LIBERTY HIGH SCHOOL Administration and Student Commons Modernization

Addendum 05

January 5, 2021

SITE DETAILS

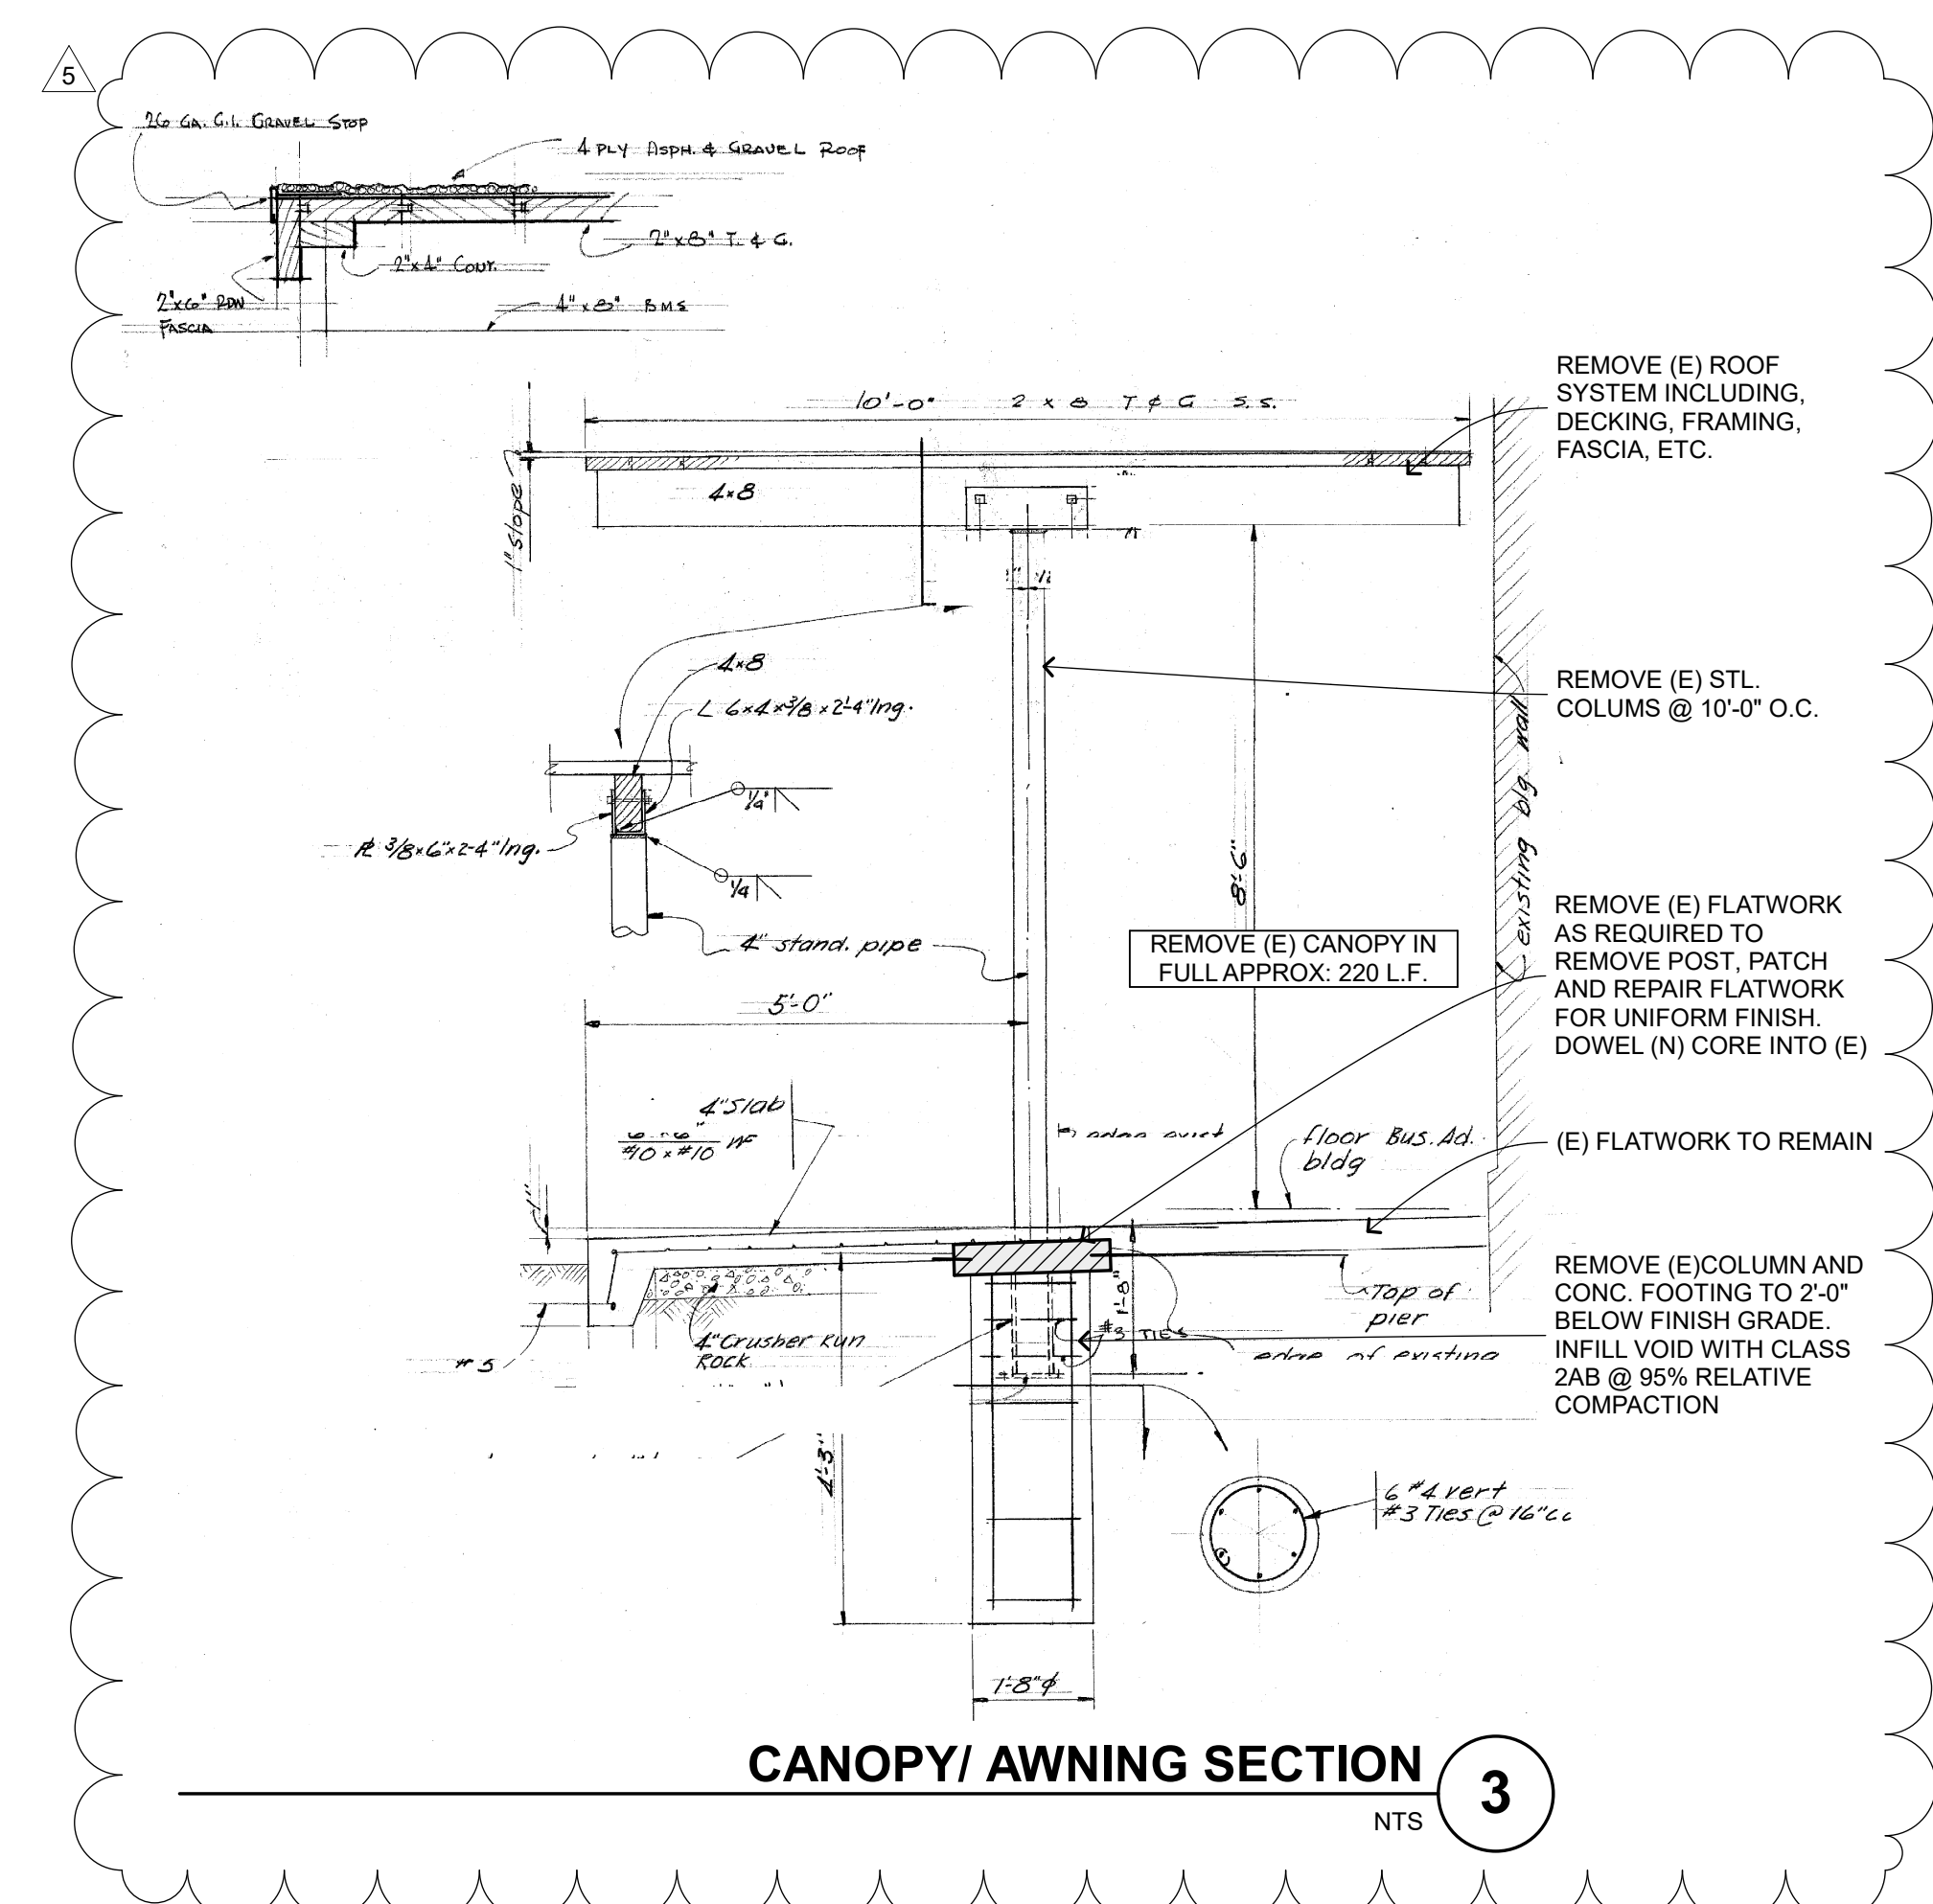
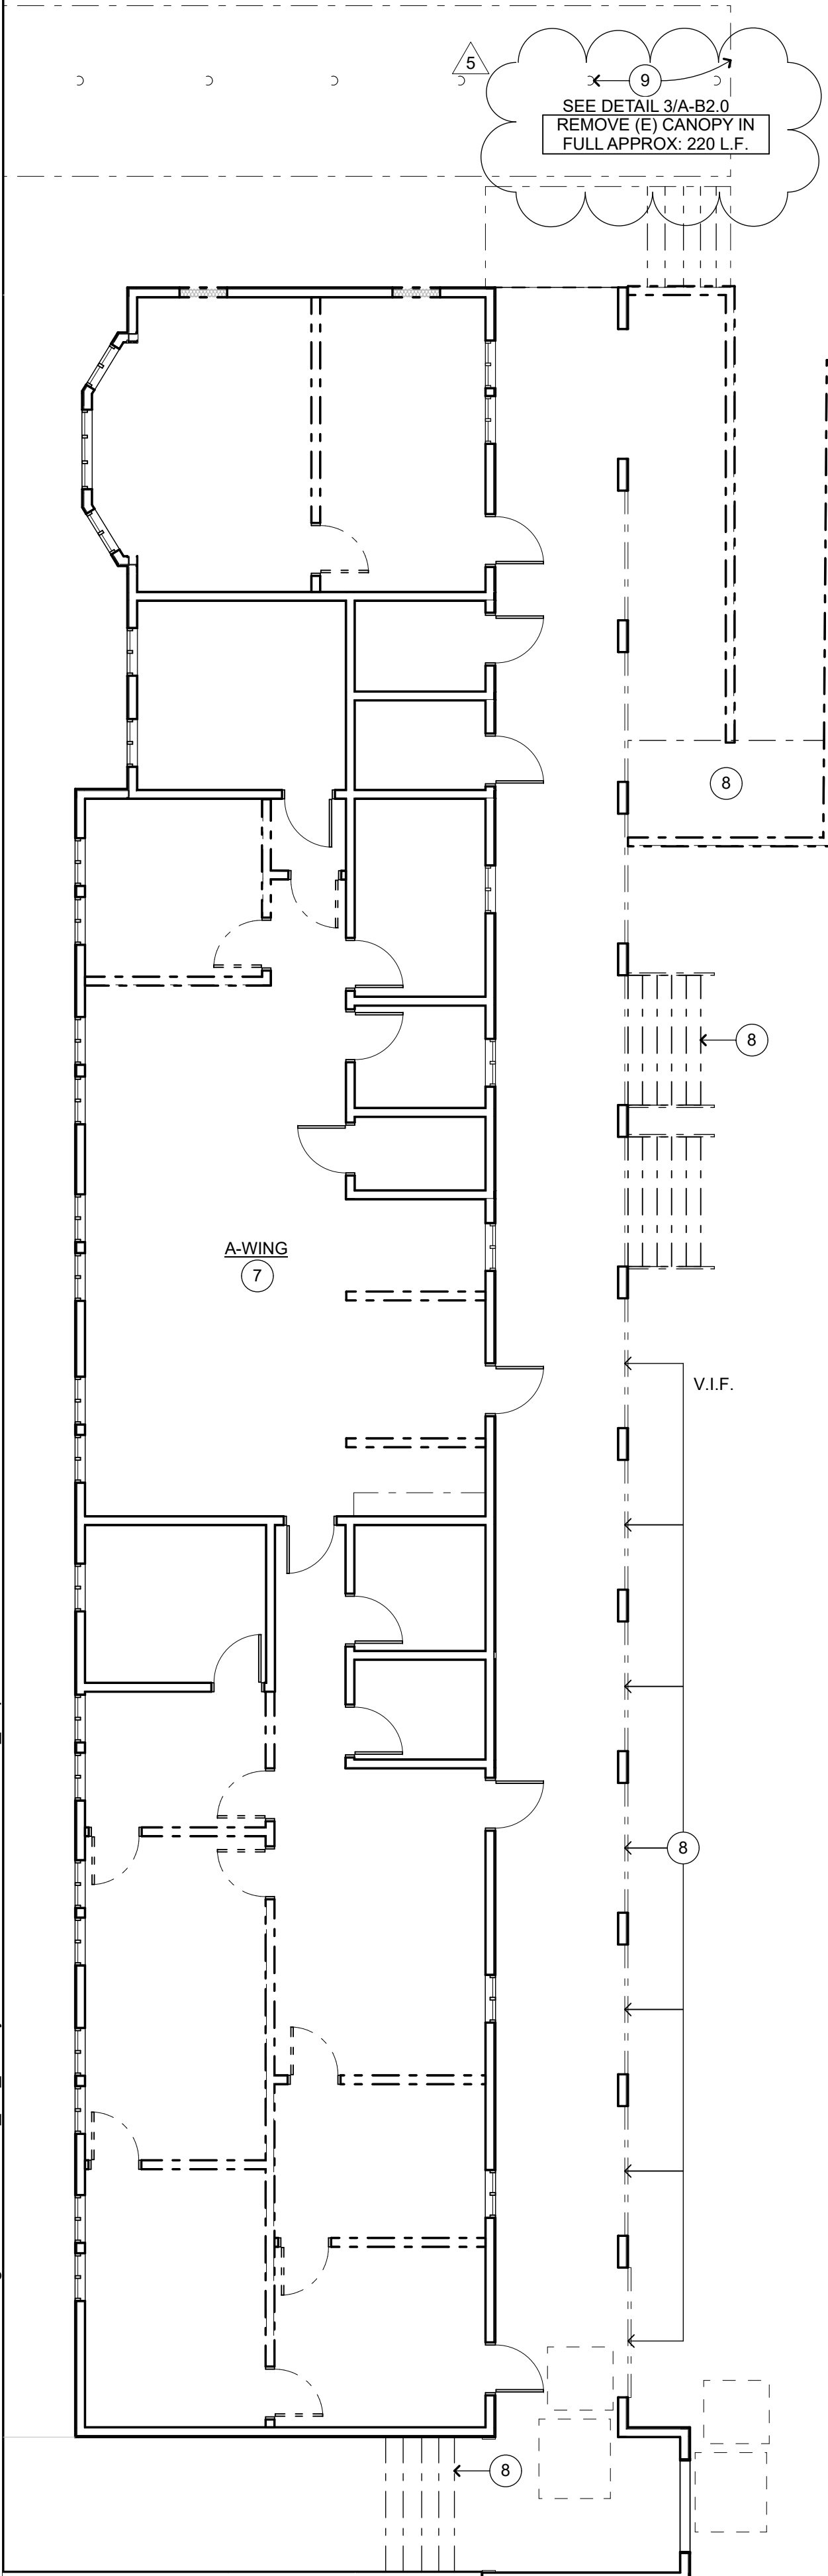
Q: Please reference the entry gate shown on A-A2.1; This detail calls out to reference detail 28/A-1.2, which in turn directs you to provide a Ameristar bi-fold roll gate or similar. Ameristar does not manufacturer bi-fold roll gate. Please advise on design intent.

A: See changes to drawings

CD
DECEMBER 28, 2020
SHEET TITLE
CAFETERIA AND A-WING BUILDINGS DEMOLITION PLAN

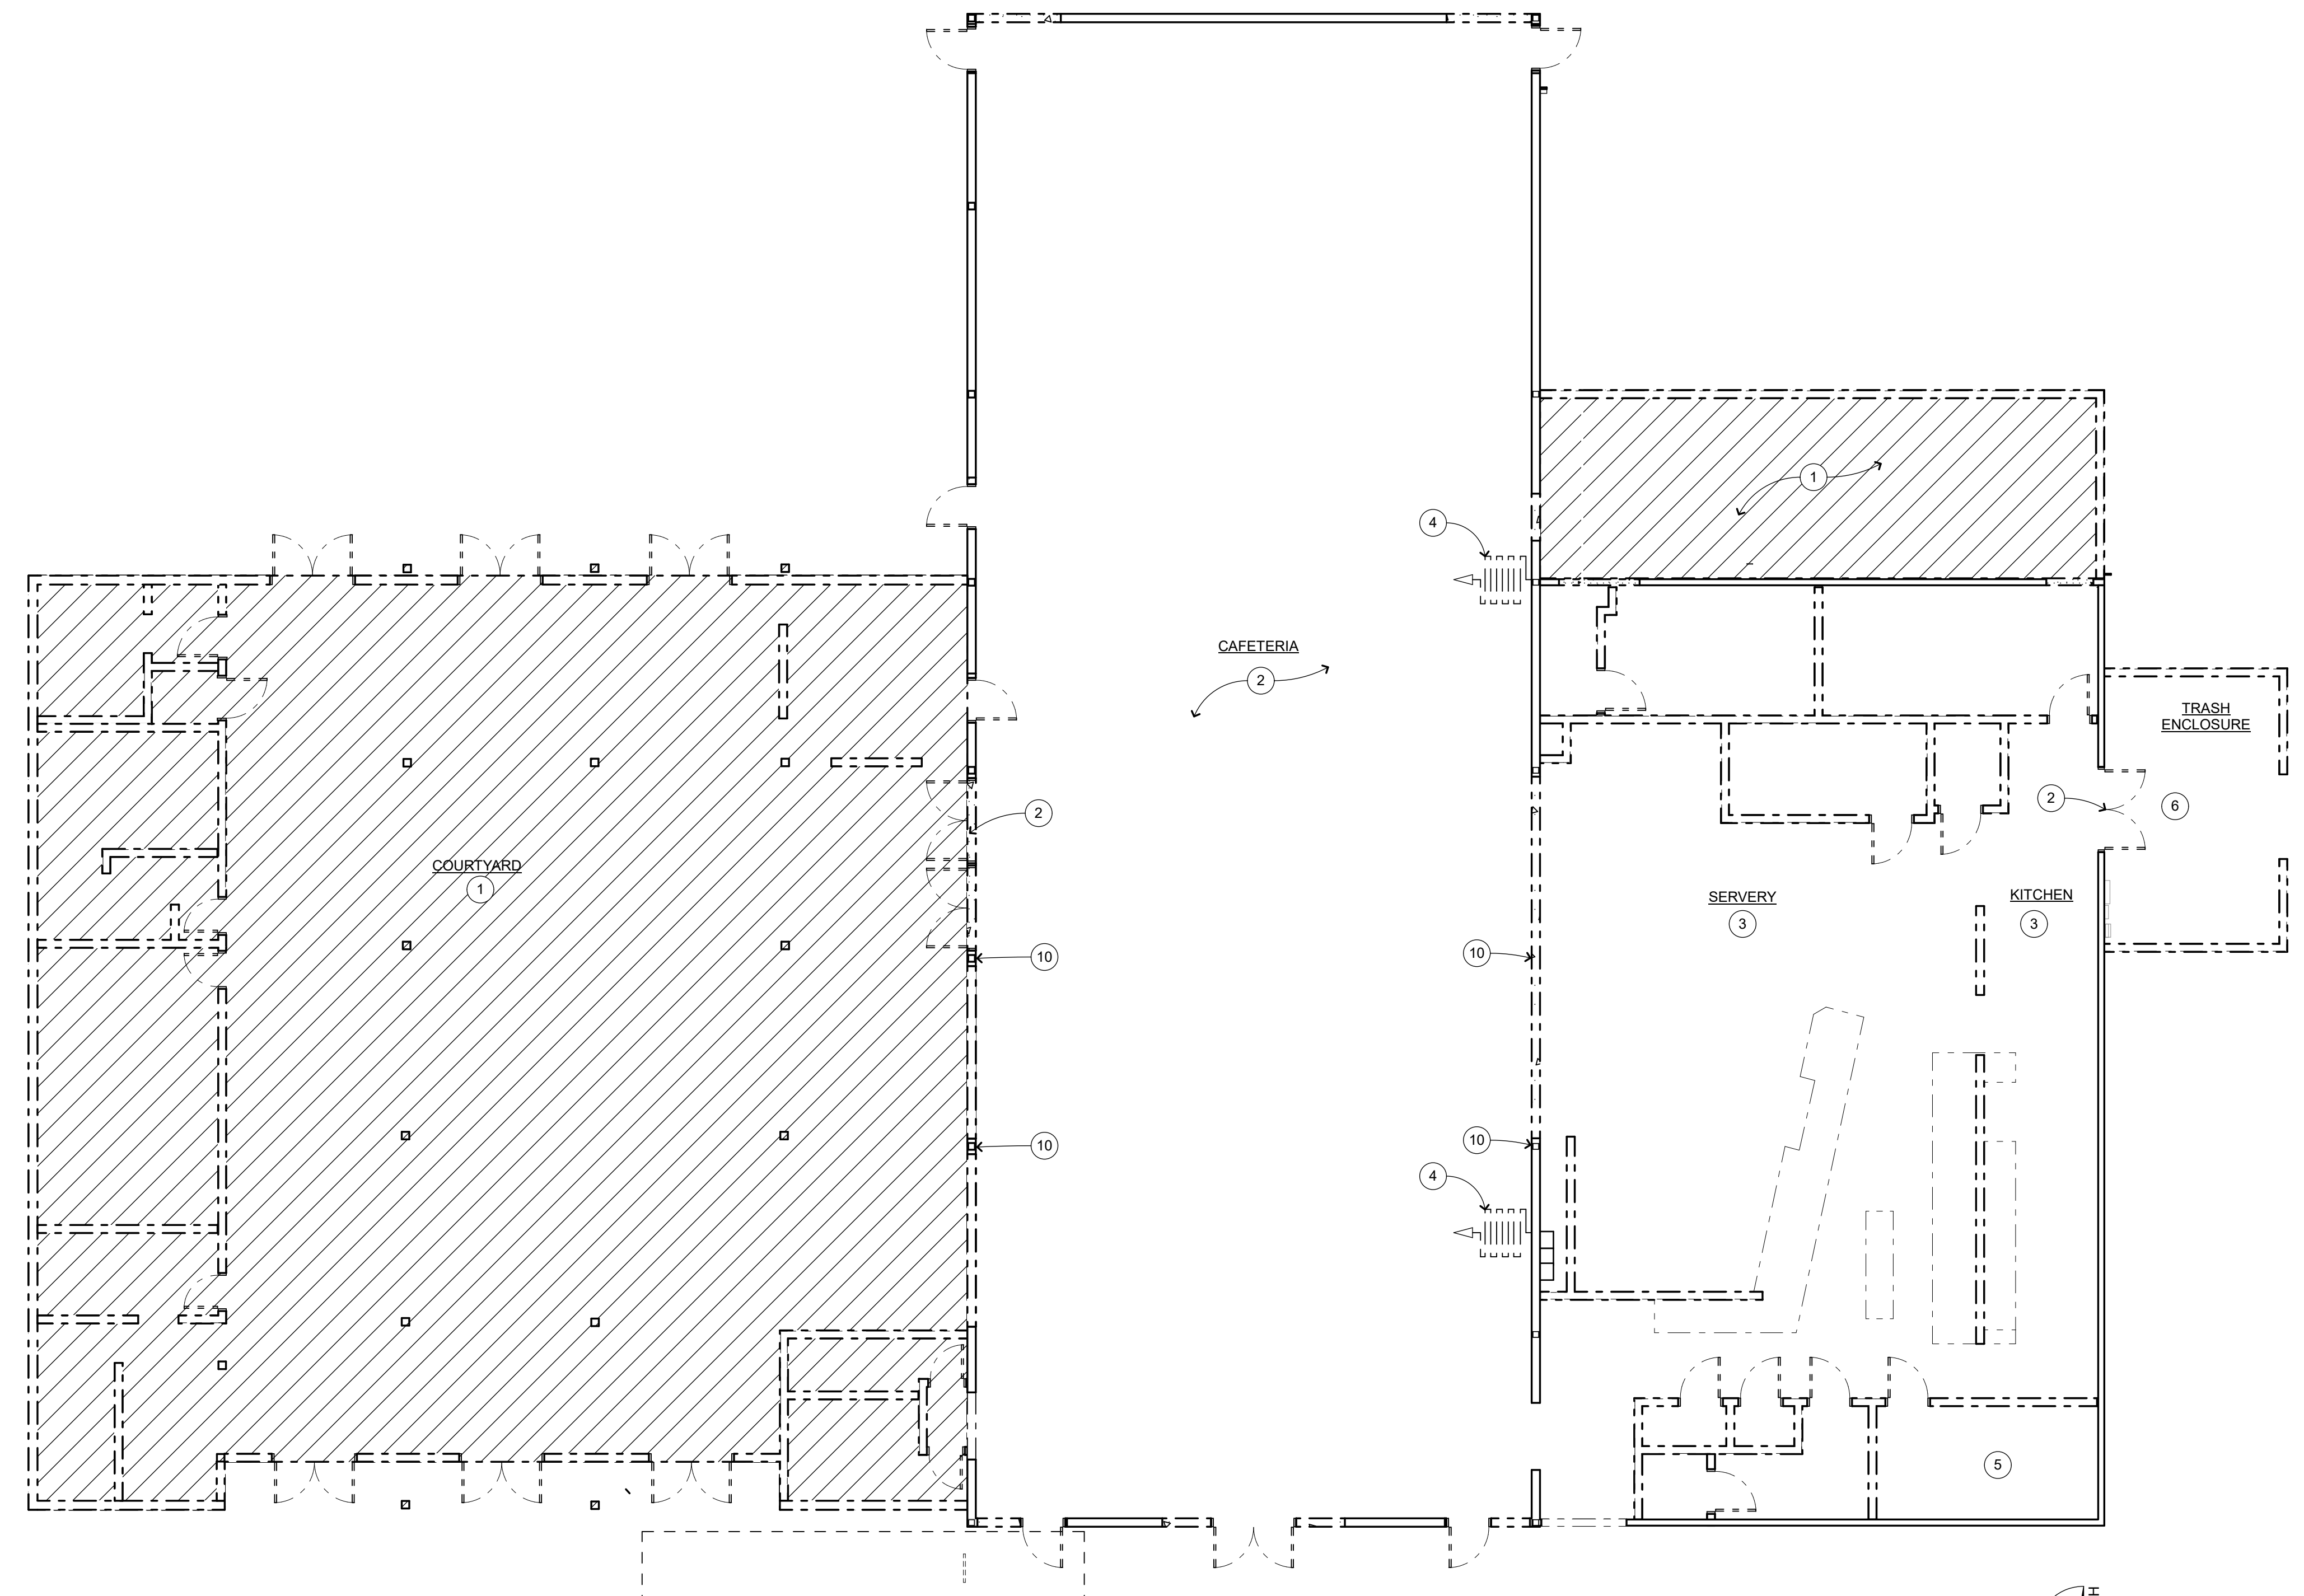
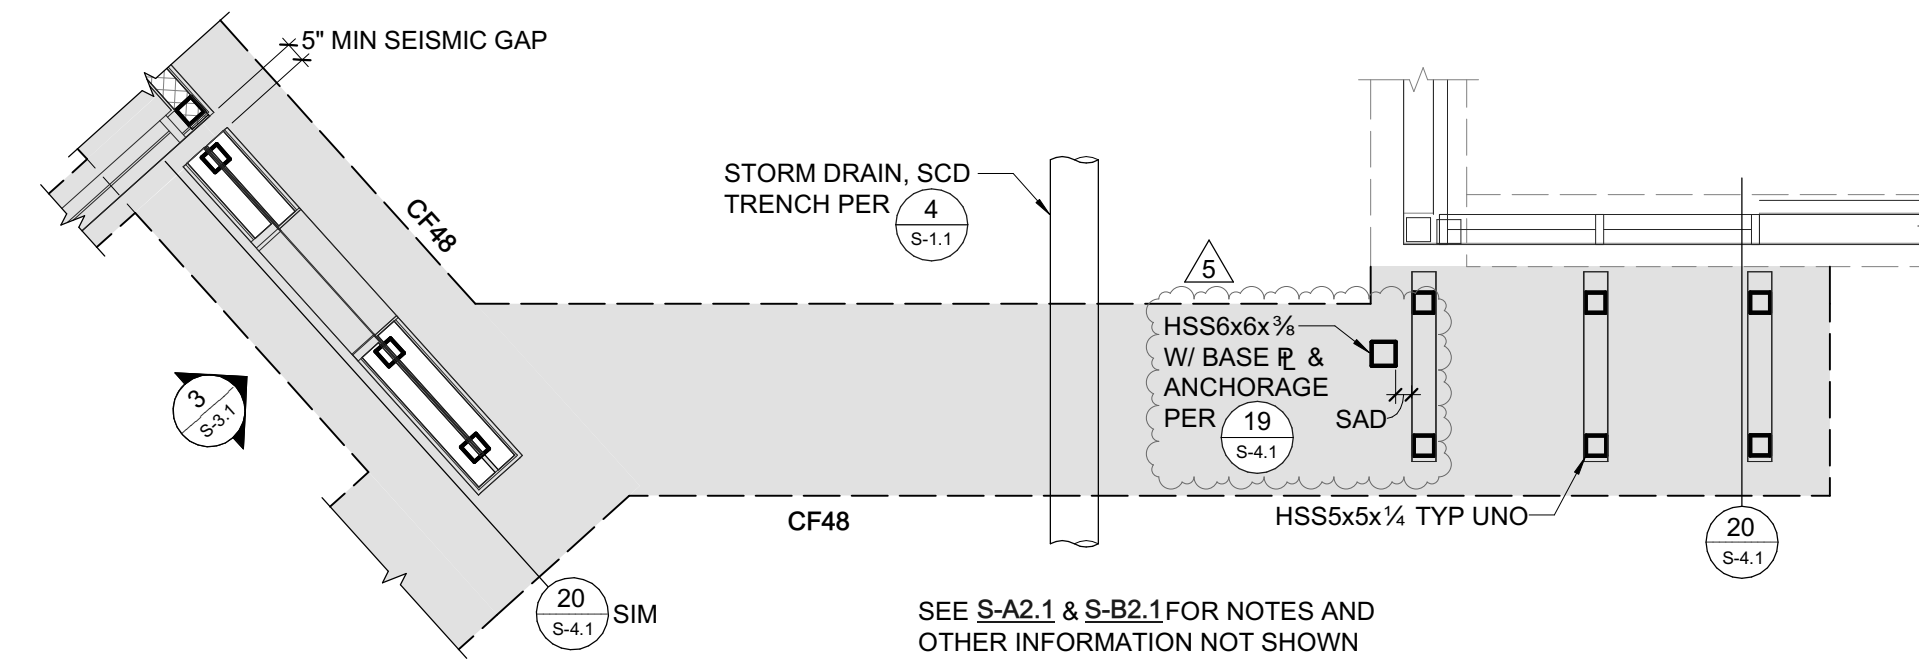
Q: Page C-1.0 calls to remove awing adjacent to Wings A-D. This work doesn't show on the A & B architectural drawings. Can you provide more information, elevation, pictures, etc?

A: The original section drawing of the canopy with a note on the overall length of the canopy and how to restore the flatwork at the location of the removed columns have been added to Sheet Addendum A-B2.0 CAFETERIA AND A-WING BUILDING DEMOLITION PLANS.
